Addendum 9: United Nations Global Technical Regulation No. 9

United Nations Global Technical Regulation on Pedestrian Safety

Amendment 3

Established in the Global Registry on 26 June 2024

"Figure 10.

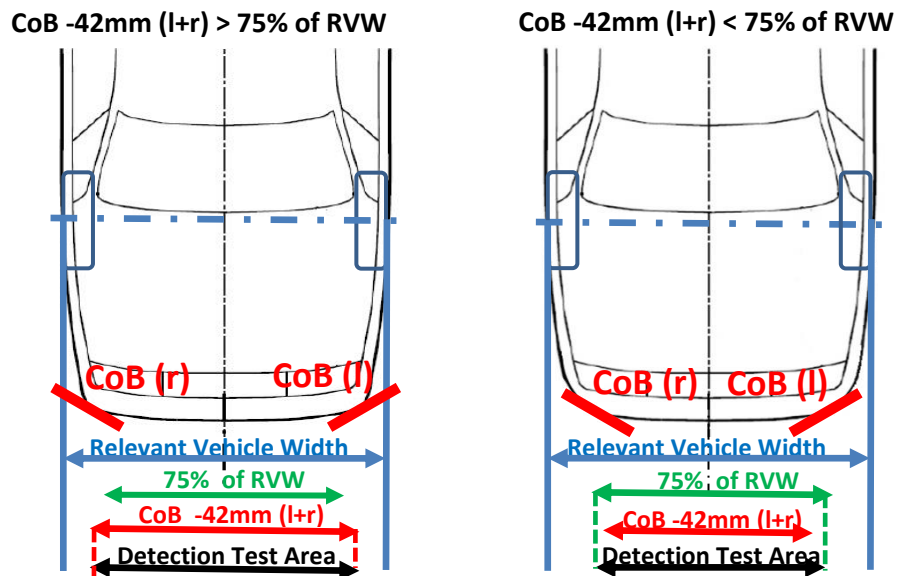
Figure 10, the title, amend to read:

Wrap around distance (WAD) measurement (see paragraph 3.44.)"

Figure 1-1
Deployment Time History Curve

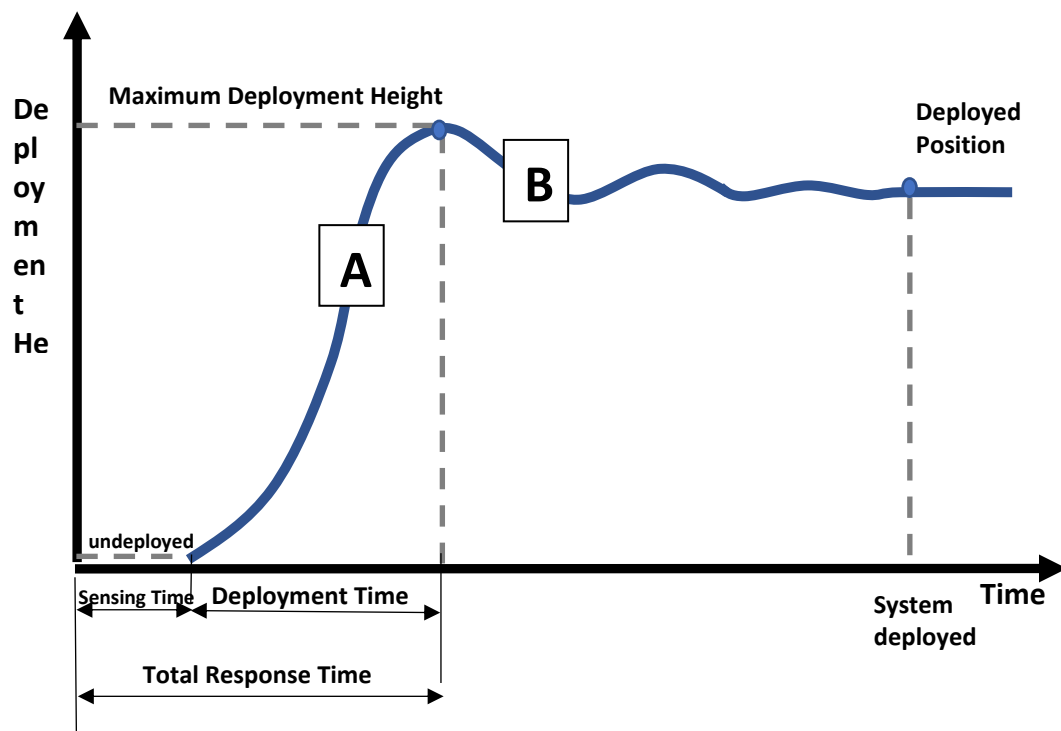
The principle of testing the DPPS is as follows:

- (a) In case of $HIT_d < TRT$, the headform test shall be performed dynamically;
- (b) In case of $HIT_d \geq TRT$, the headform test may be performed either statically at a height no more than the deployed position or dynamically.

Figure 1-3
Head Impact Time(s for synchronisation) versus Wrap Around Distance (HIT_s vs WAD)

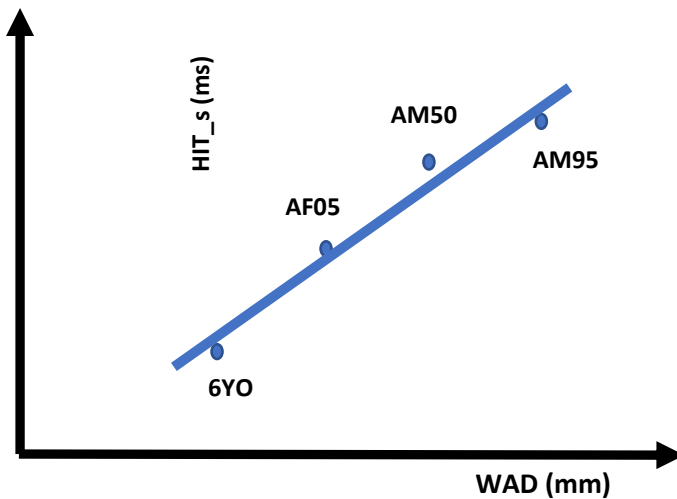
- 4.2.1.2. To enable dynamic testing to be conducted, HIT_s and ST are required inputs, which shall be established by the following:
 - (a) HIT_s (see Fig. 1-3 hereafter, obtained from Annex 2, Figure 2-3).

- 4.2.1.3. Fire Delay
The test facility shall ensure that the head impact occurs at the correct time relative to the deployment of the DPPS, taking into account the HIT_s for the corresponding WAD of the head impact point from Figure 1-3 and ST, as shown in the example in Figure 1-4 (a) below.
"Fire Delay" is the elapsing time between the initiation of the headform launch and the initiation of the DPPS deployment module.
It is determined according to the equation:
Fire Delay = Launching Duration Headform Impactor – (HIT_s – ST).
The "Launching Duration Headform Impactor" is rig-specific and is the time period between launching of the headform impactor and the theoretical time of head impact on the undeployed DPPS. Due to the DPPS deployment during

Figure 1-5
 Scheme of HIT_d vs WAD for Combined Testing

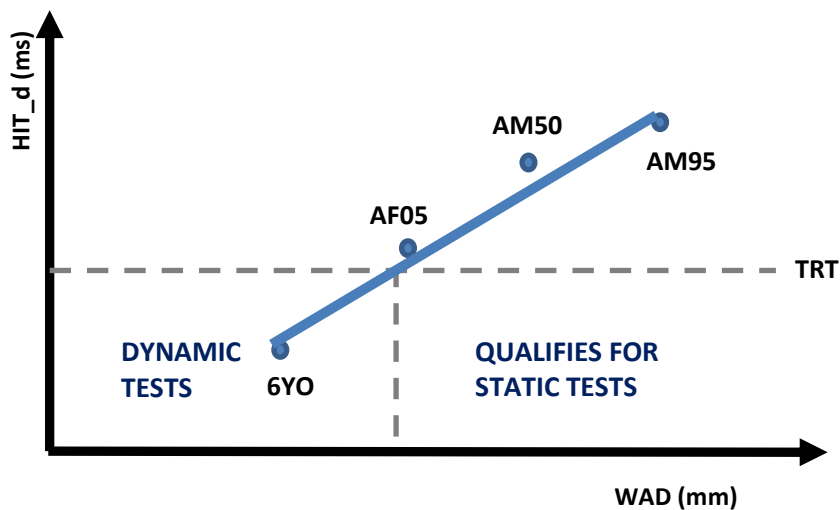
If the headform test area consists of sections where the HIT_d at the corresponding impact point is less than TRT (HIT_d < TRT), as in the A section in Figure 1-1, and sections where the HIT_d at the corresponding impact point is greater than or equal to TRT (HIT_d ≥ TRT, as in the B section in Figure 1-1, then all test points forward of the corresponding WAD (HIT_d < TRT) shall be tested dynamically. The remaining section of the headform test area may be tested statically (see Figure 1-5 below, obtained from Annex 2, Figure 2-2).

Figure 2-2
Wrap Around Distance versus Head Impact Time_for decision
(WAD vs HIT_d)

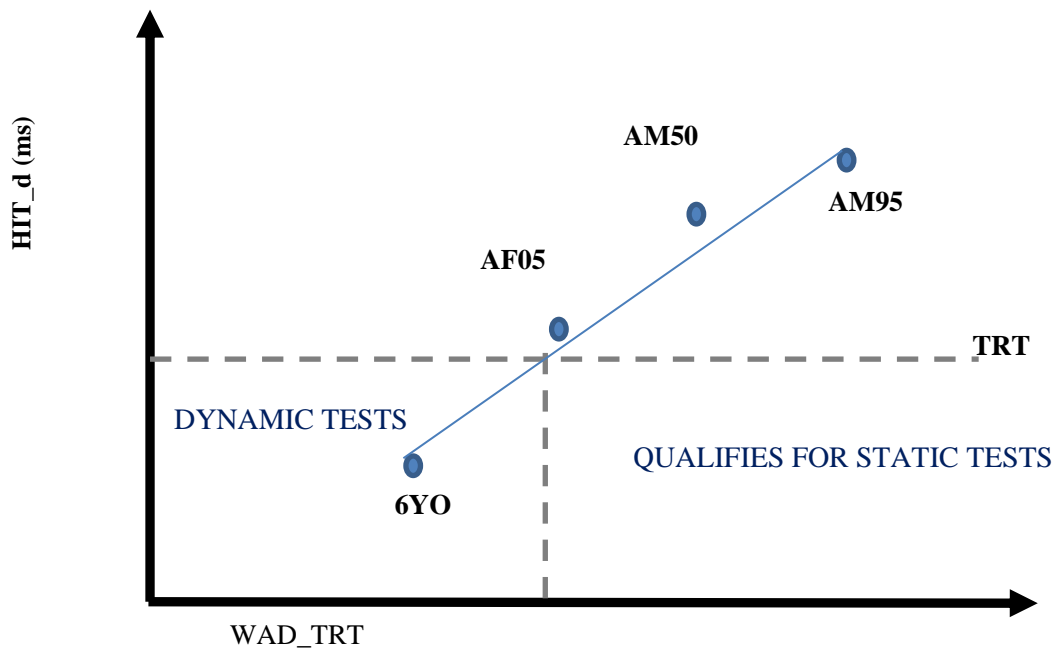
Based on the results of Table 2-3, a graph shall be plotted using a linear regression line for comparison with TRT in the diagram as shown in Figure 2-2.
